## ADDENDUM NO. 2

OWNER: Town of Tignall

PROJECT: Wastewater Treatment Plant Improvements

**HYDRAULIC PROFILES**

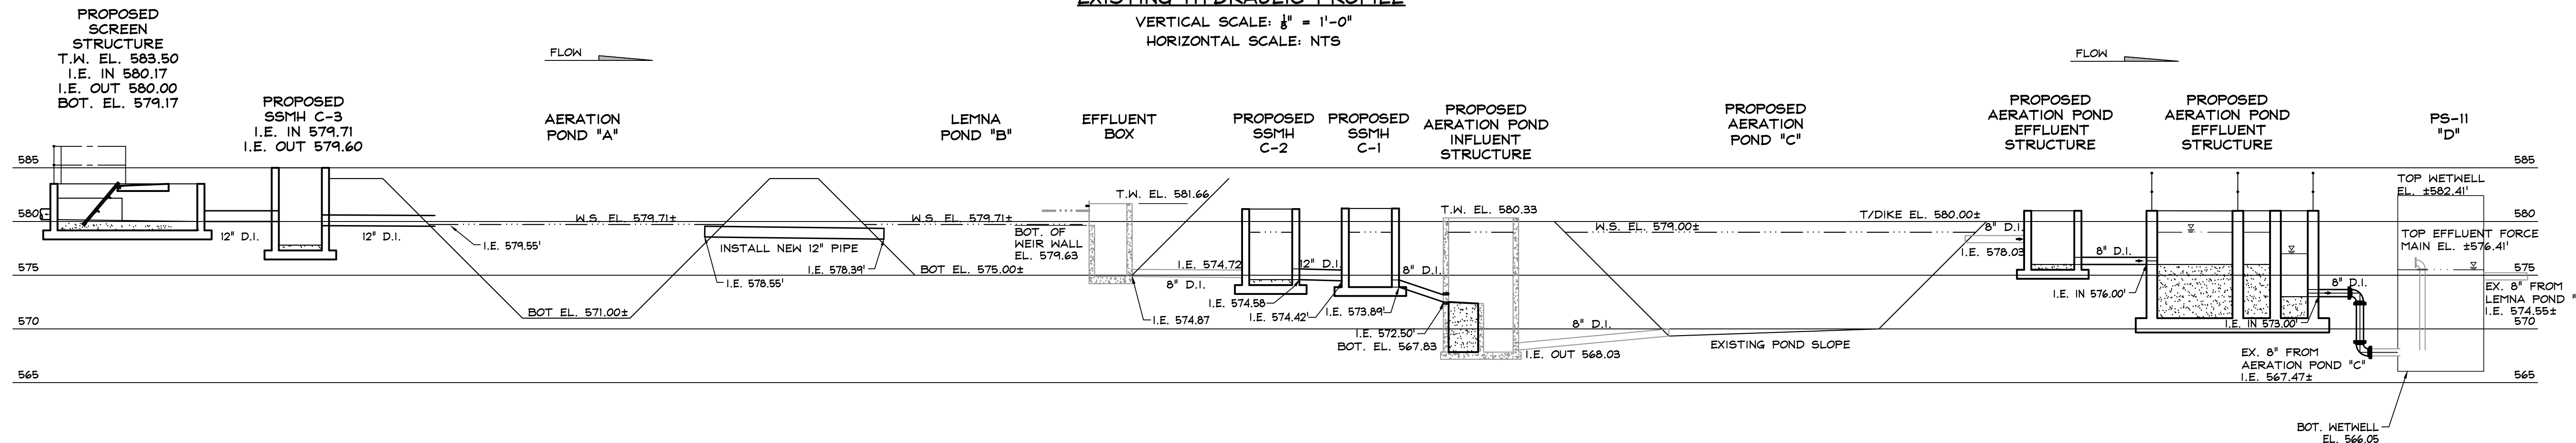
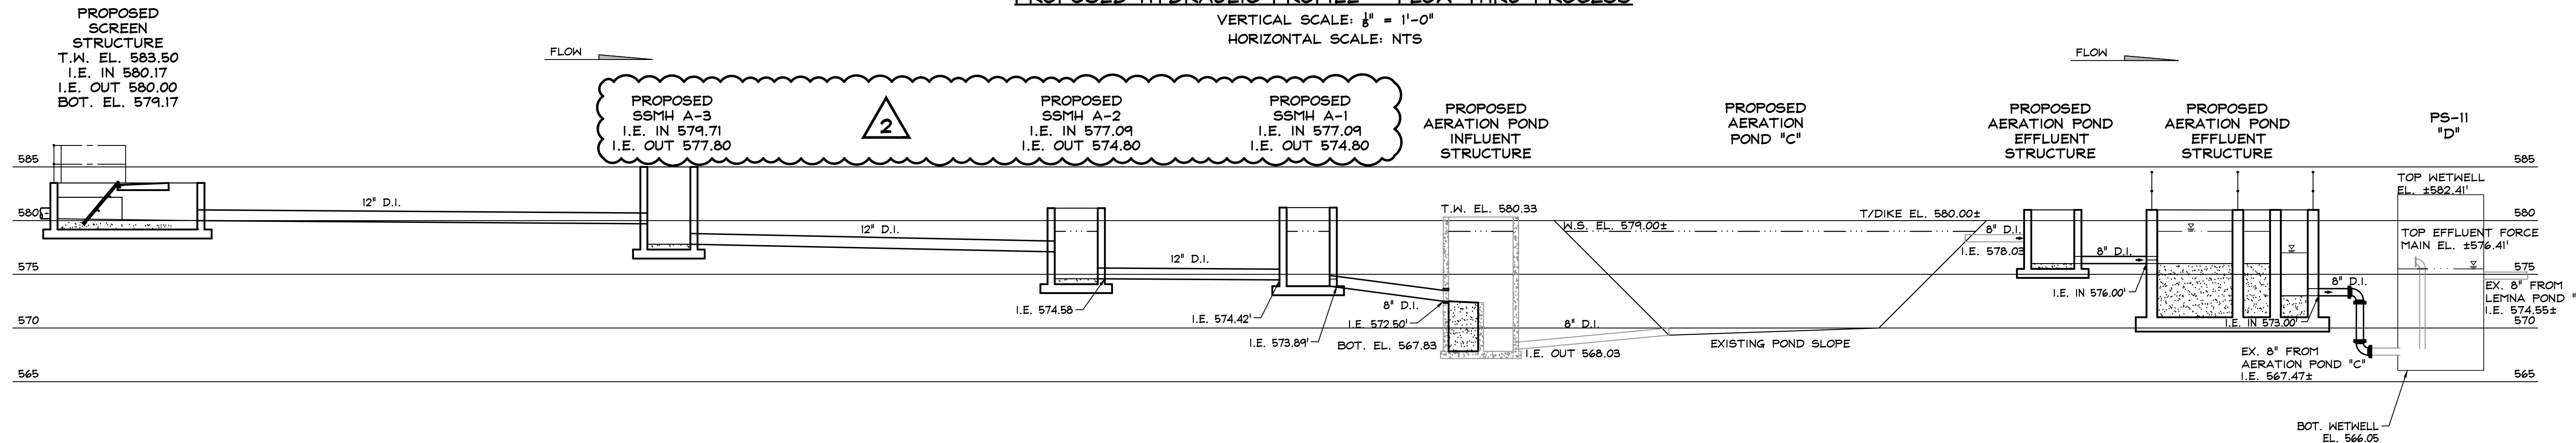
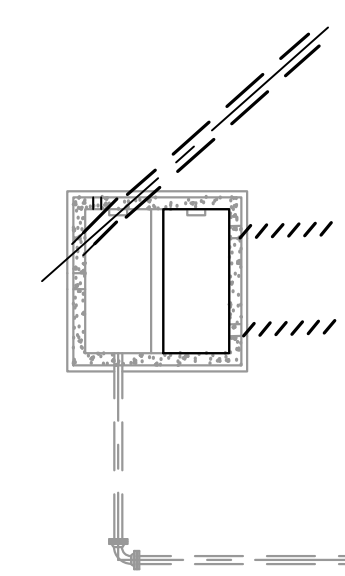
43. **Question:** Sheet 3 shows SSMH's C-1 thru C-3; however, on Sheet 7/8 the only manholes shown are A-1 thru A-4. Please confirm that the manholes should be provided as shown on sheet 7/8.

**Answer:** Manholes shall be provided as shown on sheet 7&8. See revised sheet 3 included in this Addendum.
44. **Question:** Please confirm what diameter manholes A-1 thru A-4 should be.

DSGN: MB	DRWN: JB
SCALE: AS SHOWN	
PROJ. NO.: T7040.003	
DATE:	SHEET NO.: 7

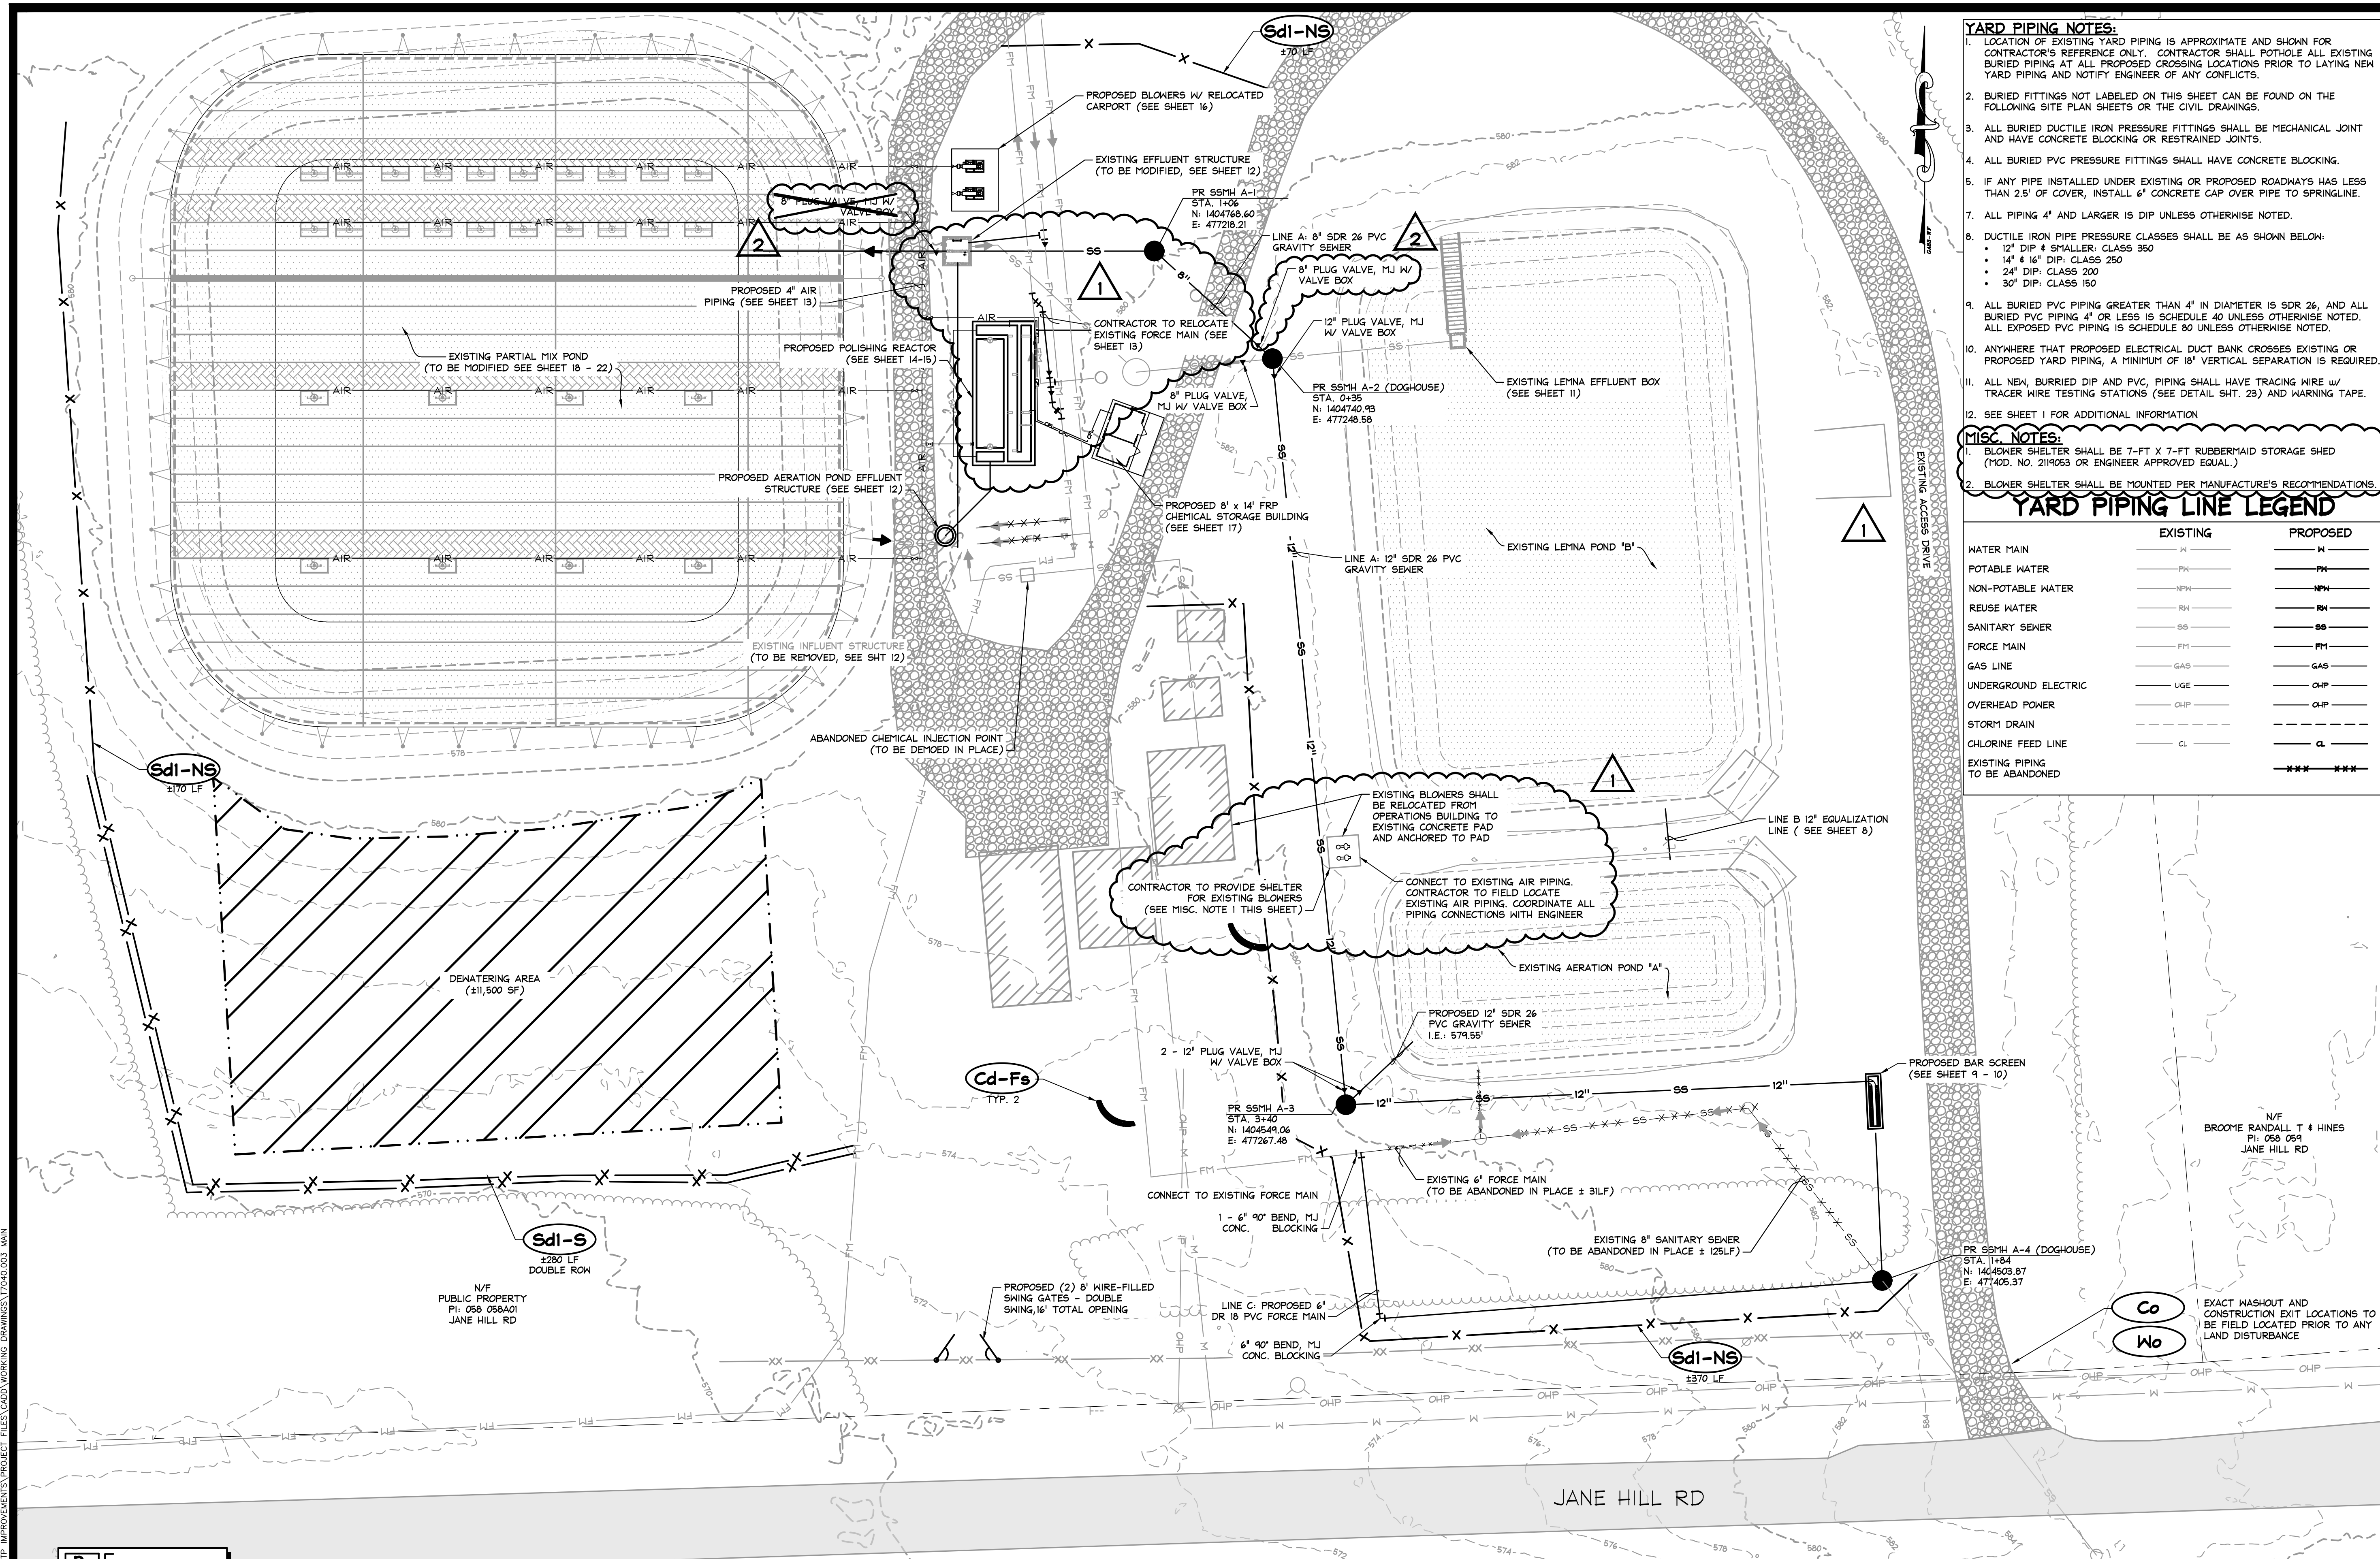
**Answer:** The fiberglass grating manufacture can supply their standard detail for mounting in a concrete slab.
23. **Question:** Please confirm that the plug valve between SSMH A-1 and SSMH A-2 is to be 8" and not 12". The plug valve is shown as 8" on Sheet 8 but 12" on Sheet 7.

**Answer:** The plug valve between SSMH A-1 & SSMH A-2 is to be an 8" valve. See revised Sheet 7 enclosed in this Addendum.
24. **Question:** Please confirm the intention with the pipe wall detail on Sheet 23 and what would differentiate the use of the left or right details. We are assuming the right detail can be used for pipe penetrations through new walls.

POLYMER CONCRETE CHEMICAL PULL BOX  
 N.T.S.

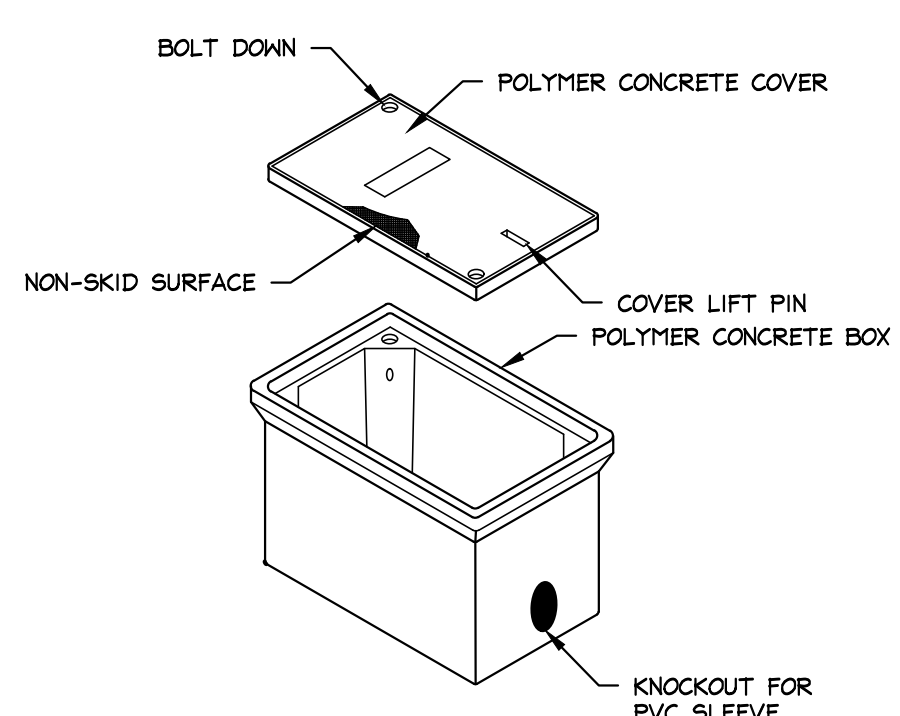
**Answer:** See Sheet 9 "Top Plan" for pad dimensions.
21. **Question:** Sheet 17 says "See 26 for detail" related to the chemical piping pull box. However, there is not a detail for the pull box on sheet 26. Can a detail for the pull box be provided?

**Answer:** Please see modified sheet 26 included in this Addendum for the chemical piping pull box detail.
22. **Question:** Can details or specifications be provided for the fiberglass grating in the chemical storage building, or will the fiberglass grating reflect the aluminum grating details on Sheet 26?

**ELECTRICAL SITE PLAN**  
SCALE: 1/4" = 1'-0"

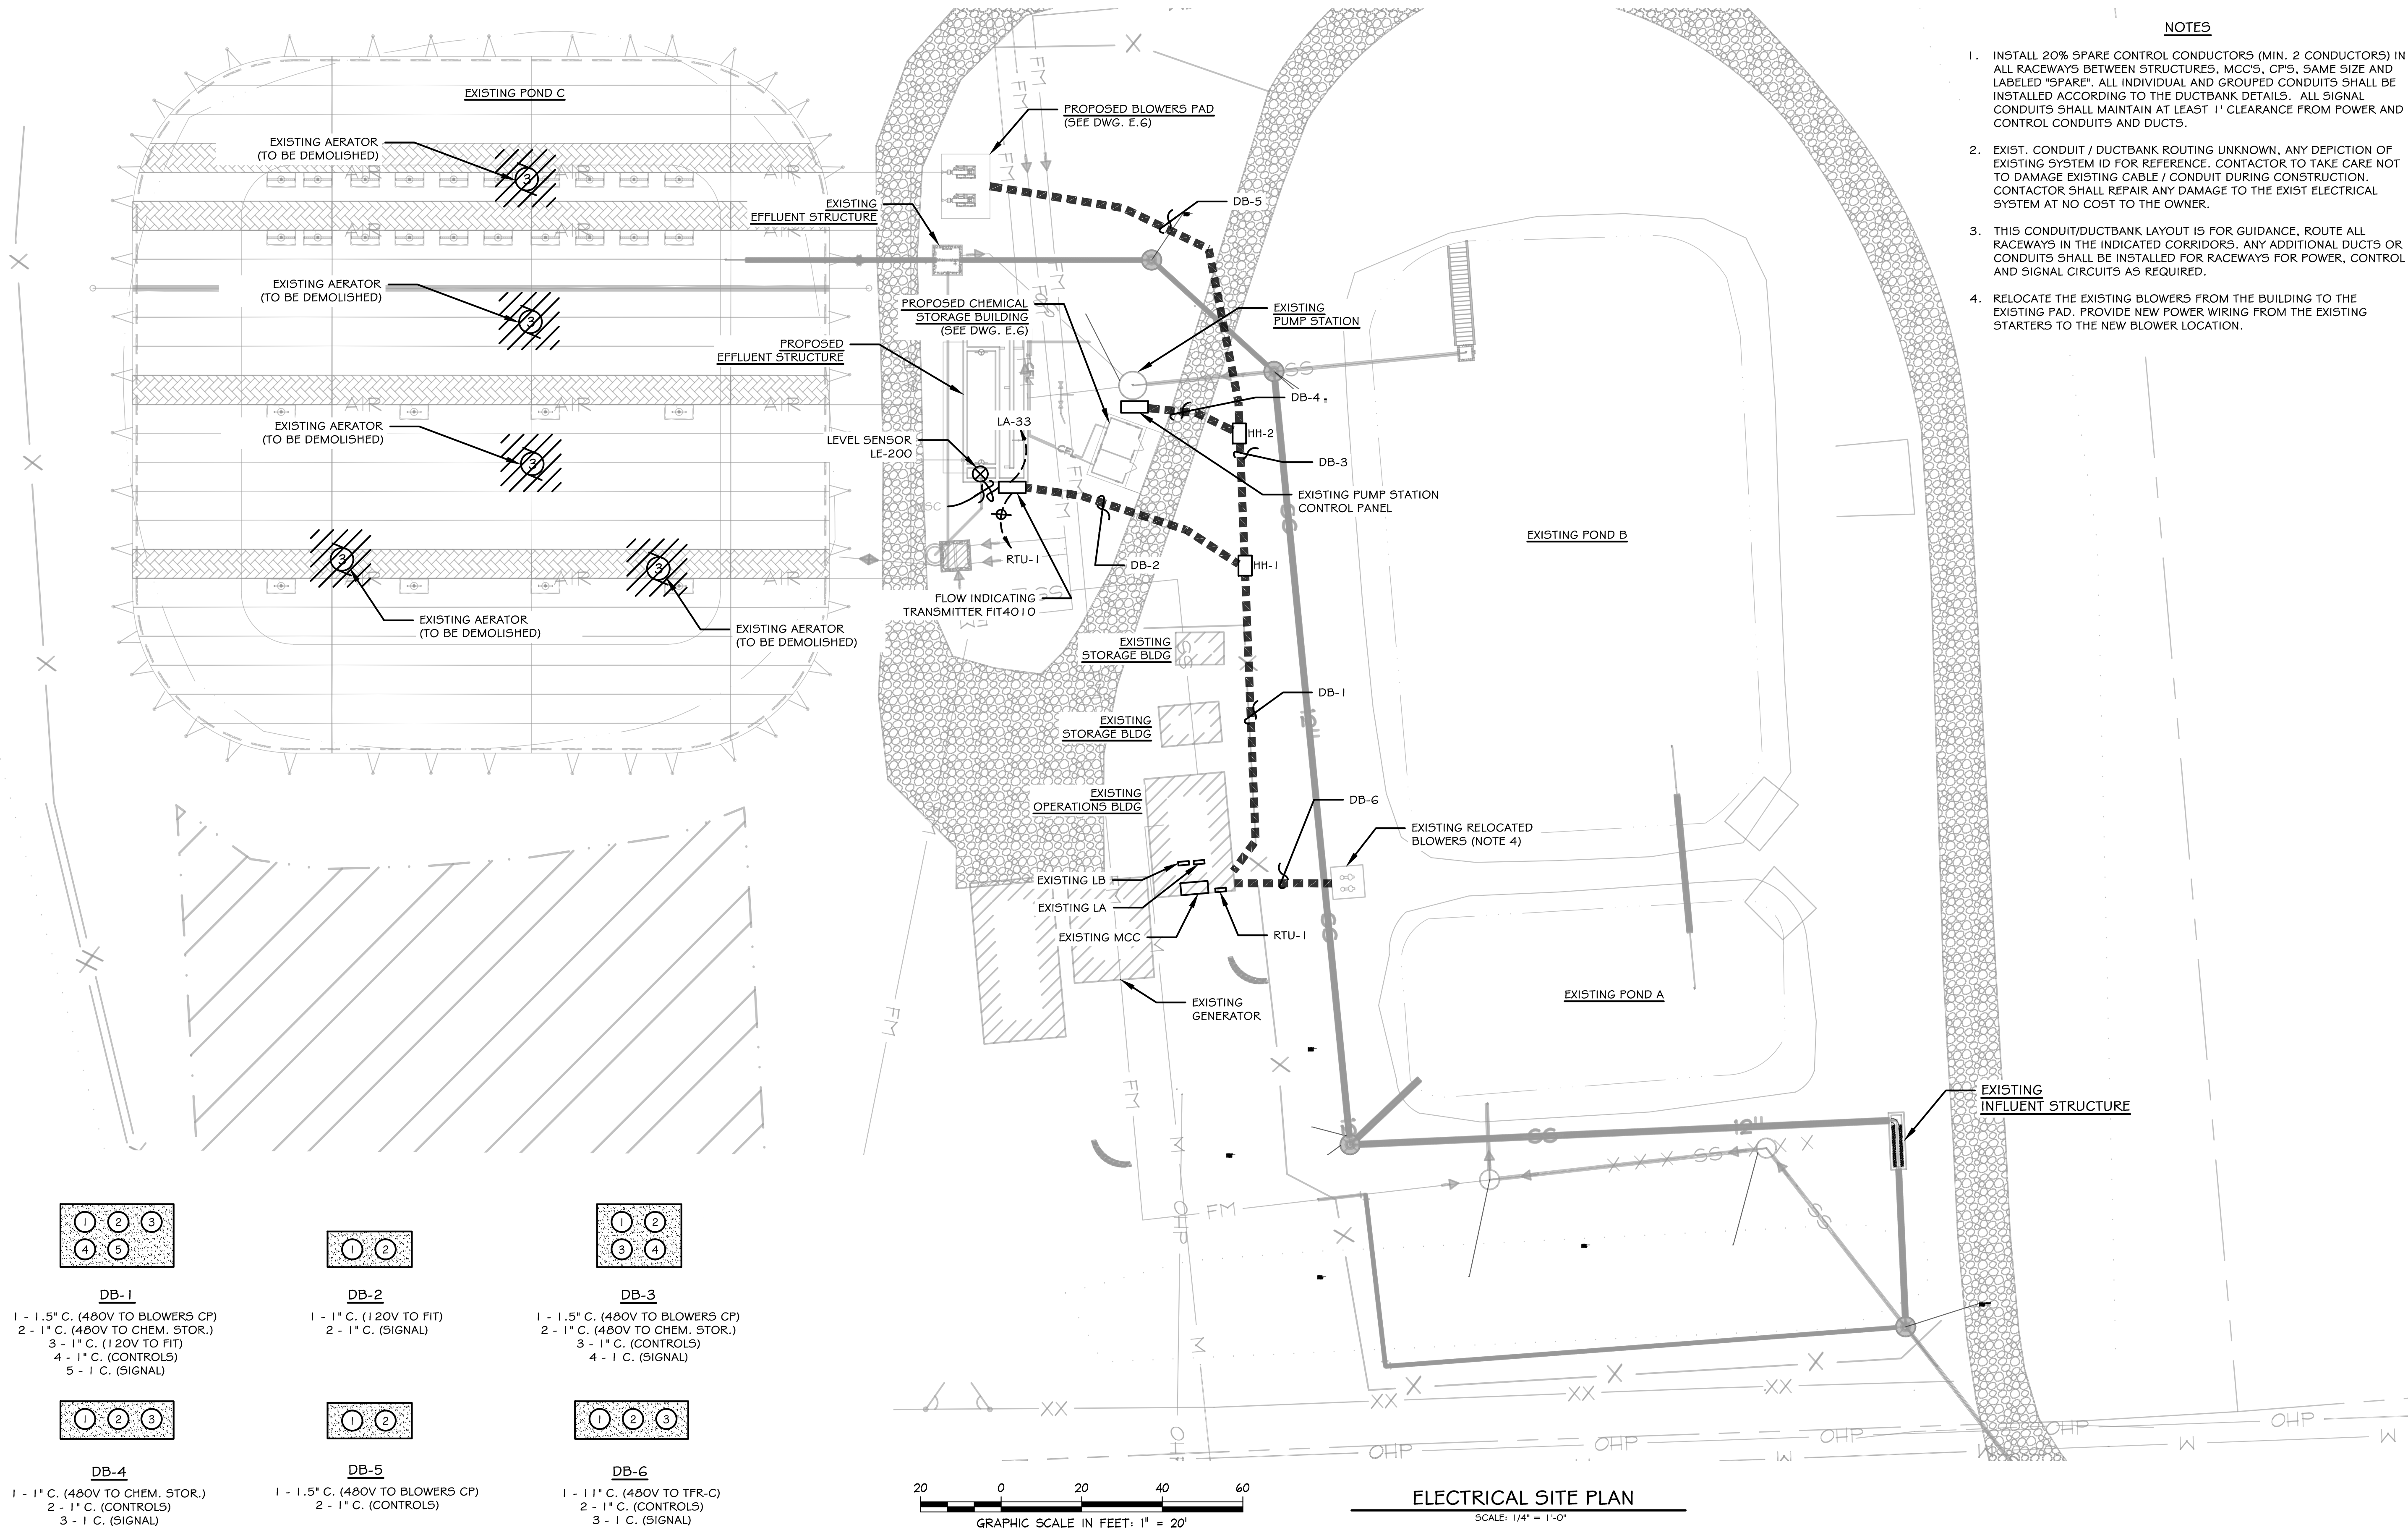
52. **Question:** With respect to electrical ductbanks, Sheet E.4 appears to indicate concrete-encased ductbanks, while Sheet E.5 appears to depict sand-filled ductbanks. Please clarify which installation type is required.

- Answer:** Electrical ductbanks installed under roadways shall be concrete-encased. Ductbanks in all other areas shall be sand filled.
53. **Question:** Will the TFR-C on E.3 be 3R since this is shown outside on E.6?
